Access Compliance Report Public Rights-of-Way (Curb Ramps)

Main Street: OCASO_ST Cross Street: AIROSO_ST Location: SE

ADA ID: RPRK211124143121 Ramp Type: Type 1 - Perpendicular Diagonal Initial Pass/Fail: Fail Overall Compliance: No Severity Score: 16

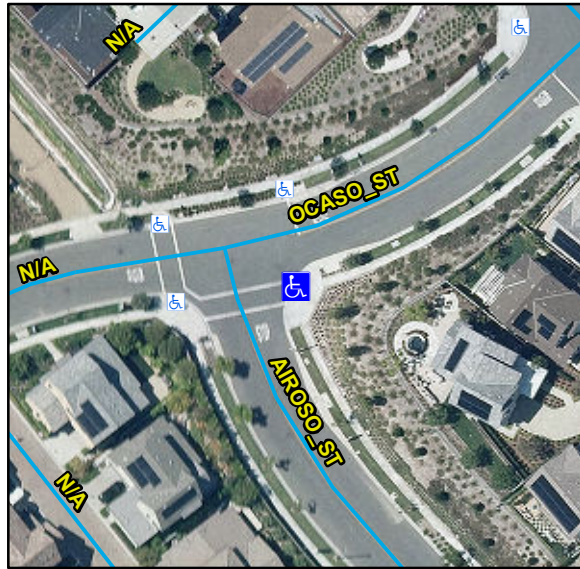
Compliance	Description	Data	Compliance	Description	Data
N/A	Ramp Length (in)	112	N/A	Flare Type LT	
Yes	Ramp Width (in)	48			N/A
No	Ramp Run Slope (%)	9.2	N/A	Flare Slope LT (%)	N/A
No	Ramp Cross Slope (%)	3.1	N/A	Flare Traversable LT	N/A
N/A	Landing Present	N/A	N/A	Flare Type RT	
N/A	Landing Length (in)	N/A			N/A
N/A	Landing Width (in)	N/A	N/A	Flare Slope RT (%)	N/A
N/A	Landing Run Slope (%)	N/A	N/A	Flare Traversable RT	N/A
N/A	Landing Cross Slope (%)	N/A	N/A	DWS Provided	N/A
N/A	Landing Movement Obstructed?	N/A	N/A	DWS Contrast	N/A
	Landing Movement Type	N/A	N/A	DWS Length (in)	N/A
N/A	Landing Shared	N/A	N/A	DWS Full Width	N/A
N/A	Clear Space	Yes	N/A	DWS Offset Left (in)	N/A
N/A	Clear Space To Crosswalk (in)	N/A	N/A	DWS Offset Right (in)	N/A
N/A	Marked Crosswalk 1	No	N/A	Marked Crosswalk 2	Yes
	Crossing 1 Direction	N		Crossing 2 Direction	W
	Marked Crosswalk 1 Width (in)	N/A		Marked Crosswalk 2 Width (in)	144

N/A	Ramp Inside Crosswalk 1	N/A	Yes	Ramp Inside Crosswalk 2	Yes
	Crossing 1 Slope (%)	0.3		Crossing 2 Slope (%)	0.7
	Crossing 1 Cross Slope (%)	6.7		Crossing 2 Cross Slope (%)	4.8
N/A	Gutter Ponding	N/A	No	Curb Slope	8.5
Yes	Gutter Lip Height (in)	0		Road Run Slope (%)	4.2
N/A	Gutter Run Slope (%)	N/A		Road Cross Slope (%)	5.8
N/A	Gutter Cross Slope (%)	N/A			
Yes	Overall Surface Condition: Acceptable		Yes	Perp Joint Present	Yes
	Cross Gutter Present?	No		Spandrel Present?	No
	Replace Cross Gutter?	N/A		Replace Spandrel?	N/A

Remove & Replace Curb Ramp With Two New Directional Ramps or Equivalent.

R304.2.2, R304.5.3, STD 1115
